La Marzocco Technical Bulletin #115

TL 30.03 internal tube

We would like to inform you that GS3 and Strada EE-EP internal tube has been modified.

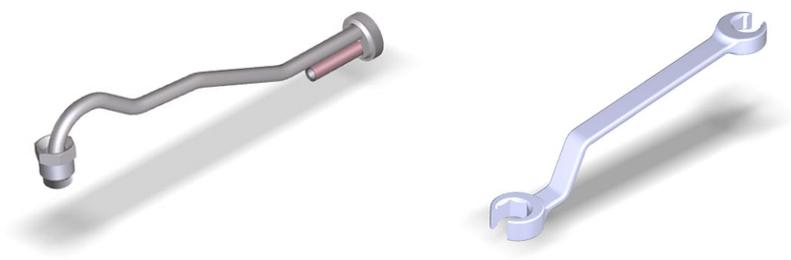
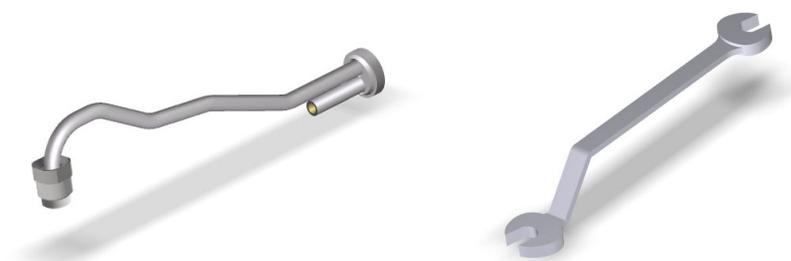
The 14mm hexagonal nut has been reduced to 13mm square nut in order to make the tube easier to remove from the group. Consequently, we will offer a 13mm open-end bent wrench (UT108) to fit the new nut since the previous wrench (UT107) is now too large to work the smaller nut. For those who have not purchased UT108, most 13 mm crow foot wrenches will work acceptably to remove the fitting.

The new spare parts are available for order through the parts department with codes:

UT108 BENT WRENCH WR13 FOR GROUP TUBE
TL30.03 INTERNAL TUBE FOR PADDLE

The new part has been included in production starting from serial number:
